P6576
4921
2215

SERVICETEKNOTES

TABLE OF CONTENTS

**492/P CENTER FREQUENCY KNOB (A38 S2035)
REPLACEMENT PARTS**

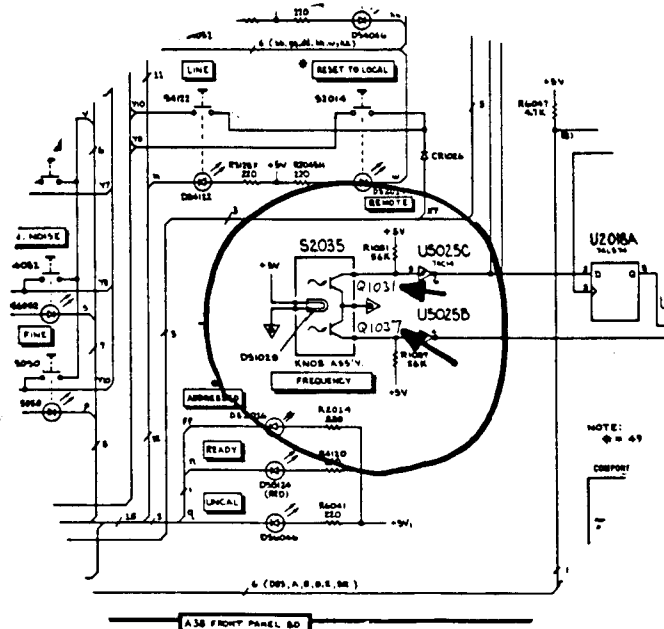
Due to the high replacement cost of (A38 S2035) the Center Frequency Knob for the 492/P, some of the internal parts were made replaceable. Refer to the figure below for the parts list and schematic locations.

492/492P	⬡30	A38	} { DS 1029 150-0093-01 Q 1037 151-0629-00 Q 1031 151-0629-00
496/496P	⬡38	A48

**492/P JUMPERS ON PRESELECTOR DRIVER
BOARD P/N 670-5552-03**

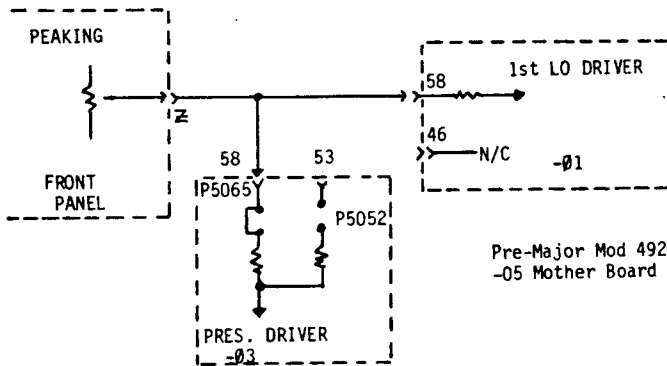
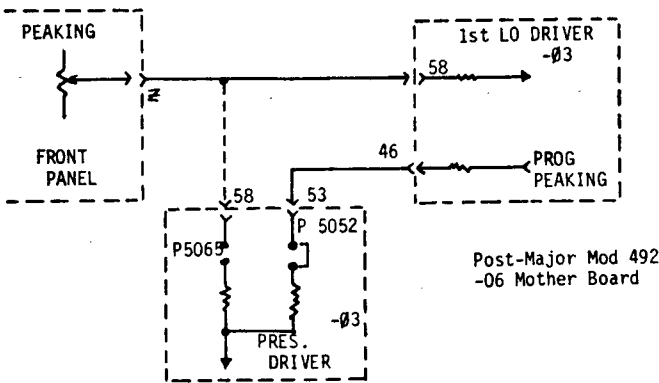
The new Preselector Driver has two plugs on it to match it to the particular first LO Driver and Mother Board with which it is being used.

1. In post major mod 492's (B03XXX and above) and all 492/P's, P5052 should have a jumper on it and P5065 should be open. This connects the Peaking control to the Preselector Driver via the first LO Driver programmable peaking output on Pin 46.
2. In pre major mod 492's (below B03XXX) with a first LO Driver, 670-5550-01 or -00, P5065 should have a jumper on it and P5052 should be open. This connects the Peaking control to the Pre-selector Driver via Pin 58 on the Mother Board connector. Pin 46 on the first LO Driver has no connection on the -01 board.

Presently in 492's with -06 Mother Boards, the Peaking control will work

with the jumper on either plug since there is an extra run in the -06 Mother Board between Pins 58 on the LO Driver, and Preselector Driver (see accompanying schematic). Connect the jumpers as in #1 above.

If the jumpers are incorrect on a 492/P, the Peaking control will be useable, but the Programmable Peaking will not work.

PARTS LOCATION GRID
SYNC GENERATOR ASSEMBLIES 670-4553-03
AND 670-4553-04 CHANGING TO 670-4553-05 AND 670-4553-06 RESPECTIVELY

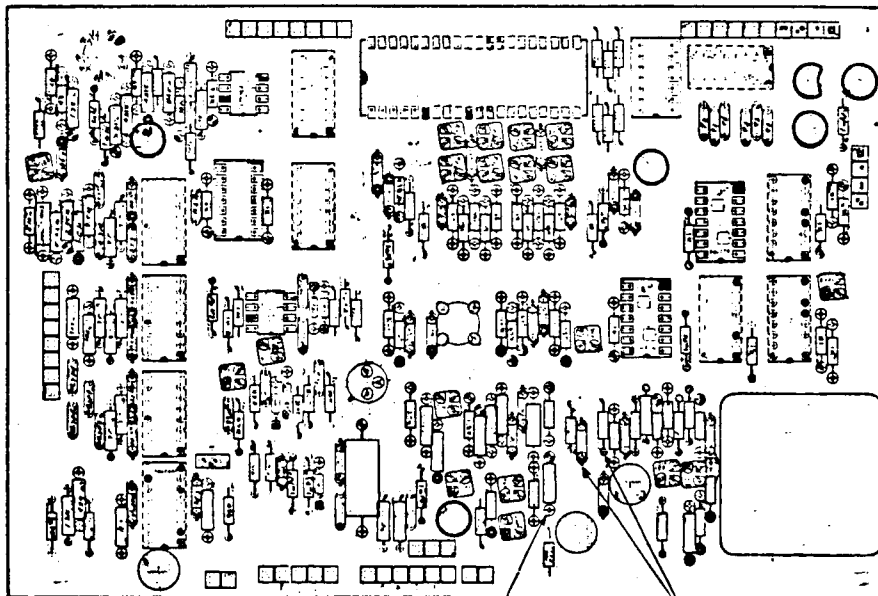
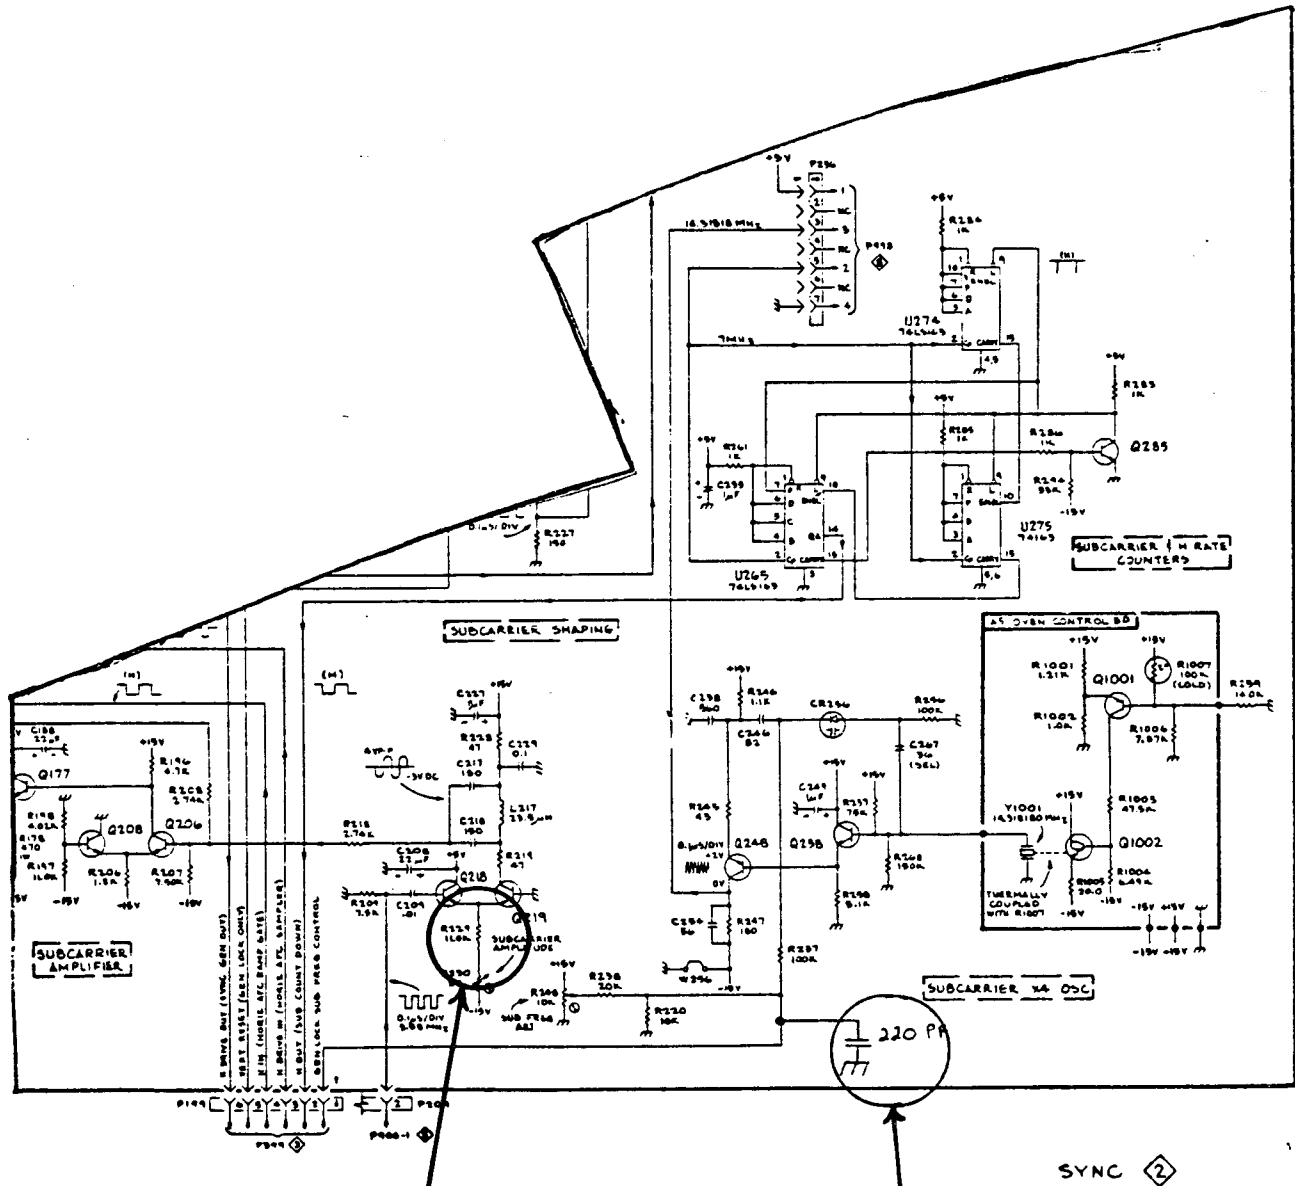
To allow the black burst adjustment (sub-carrier amplitude, R230) to be made more to the center of R230's rotation, R229 can be changed from the present 11.0K resistor to a 12.7K 1% resistor, 321-0299-00.

To assure that the subcarrier frequency remains constant when the front panel SUB-CARRIER switch is exercised in the internal mode with no Gen Lock signal applied to the rear panel, a 220pf capacitor (C237) can be added to the sync board as shown in the following diagrams.

CHANGE R229 FROM
321-0293-00 (11.0K, 1%)
TO 321-0299-00 (12.7K, 1%)

ADD C237 283-0108-00
(220pf, 10%) FROM
LEAD OF C229 TO LEAD
OF R237

Change R229 to 12.7K 1%
321-0299-00

ADDED C237 CAPACITOR
283-0108-00 (220pf, 10%)

EXPLODED VIEW OF OLD 154-0807-01 & 154-0808-01

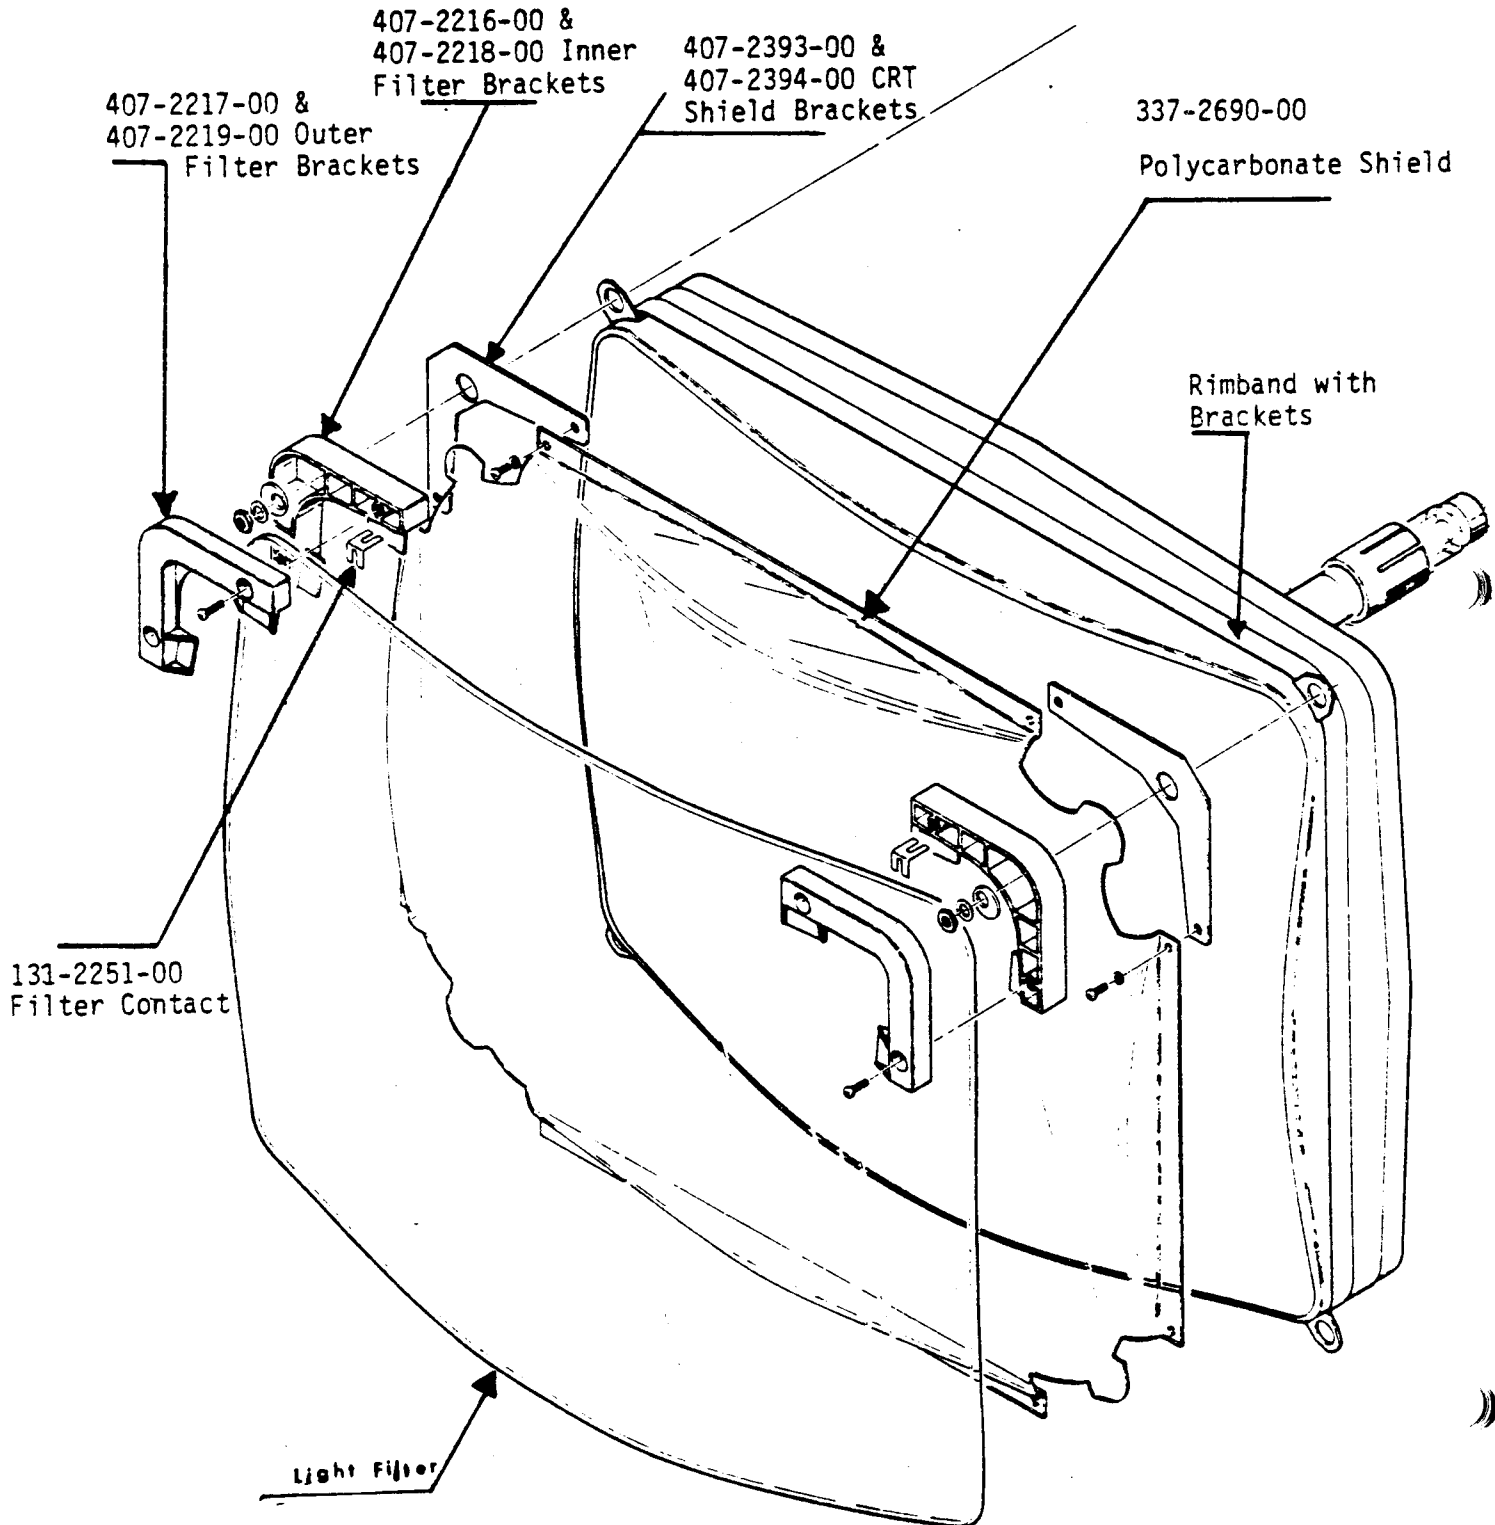
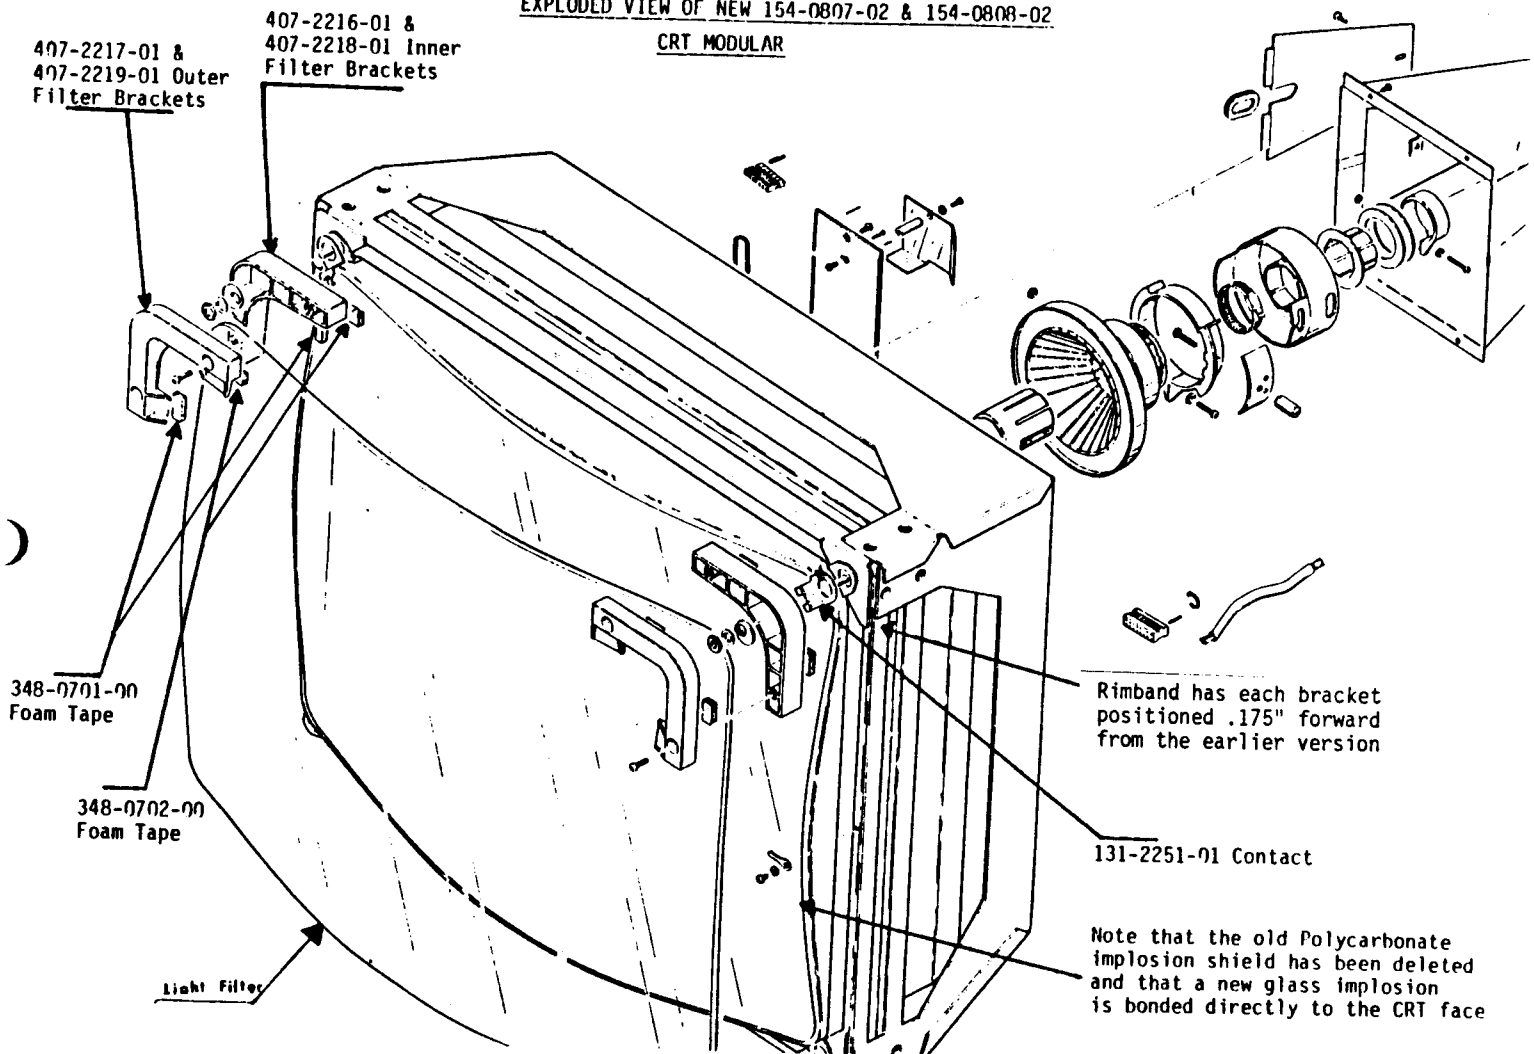
Recently all 25 inch CRT products have been modified to replace the polycarbonate implosion shield. The reason for this change is to eliminate distorted light reflections from the CRT face.

To accomplish this, a glass shield has been bonded onto the face of the CRT's in place of the polycarbonate shield.

With the additional thickness of the bonded glass shield, the CRT had to be moved back 3/8 of an inch to the rear causing the CRT JEDEC headers to be very close to the mu-metal shield wall. This could cause an electrical shorting problem unless additional space and insulation are provided. Therefore, the mu-metal shield was modified to add dimples to allow for new insulator heads that were designed to insulate the JEDEC headers.

Due to the contacting surface of the Rimband being covered with tape and epoxy as a result of bonding on the glass implosion shield, the present hardcopy filter ground clips were not functional. Also because of a redesign of the corner brackets, the brackets would not permit the ground clips to be located as before. As a result the ground clips were redesigned and are now mounted under the corner brack-

Inner Filter Brackets previously had corner tabs which caused undue stress to crack the corners of the Light Fil-

ter. These brackets were designed to eliminate the tabs.

Outer Filter Brackets remain the same except for the type of foam tape being applied to the tabs. This same foam tape is also being placed on the glass implosion shield in the same positions as the tape on the Outer Filter Bracket so as to line up and better cushion the Light Filter.

The attached exploded views show both

the old and the new versions. Note the part numbers and part names. Also note the placement of parts, especially the rubber cushions for the Light Filter. Notice that the brackets have a long and short edge. Be sure to orient them correctly when installing a new CRT module. The long edges should be in a horizontal direction.

4611/4054: GRAPHIC SYSTEM HANGS WHEN COPIER IS TURNED OFF

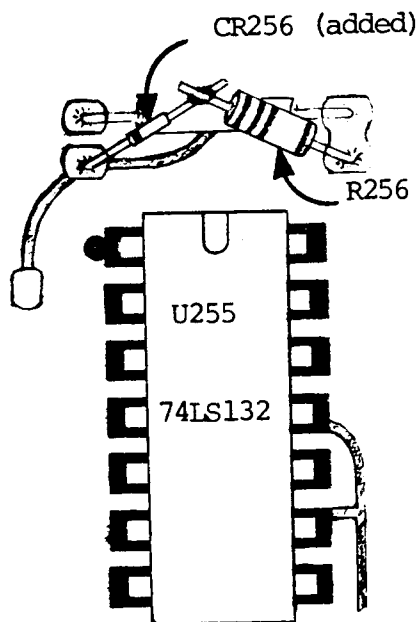
The 4054 will hang busy when connected to a 4611 that is powered down. The problem is fixed by a mod to the 4611 DVST Interface Board, P/N 670-5756-00. All 4611s with S/N B010765 and above have this mod installed.

- Disconnect power and remove the DVST Interface board from the unit.
- Locate U255 and R256 just above it.
- Lift the left end of R256.
- Solder in a diode (P/N 152-0141-02) cathode down, in series with R256. See illustration.

The part number suffix of the board rolls to 670-5756-01.
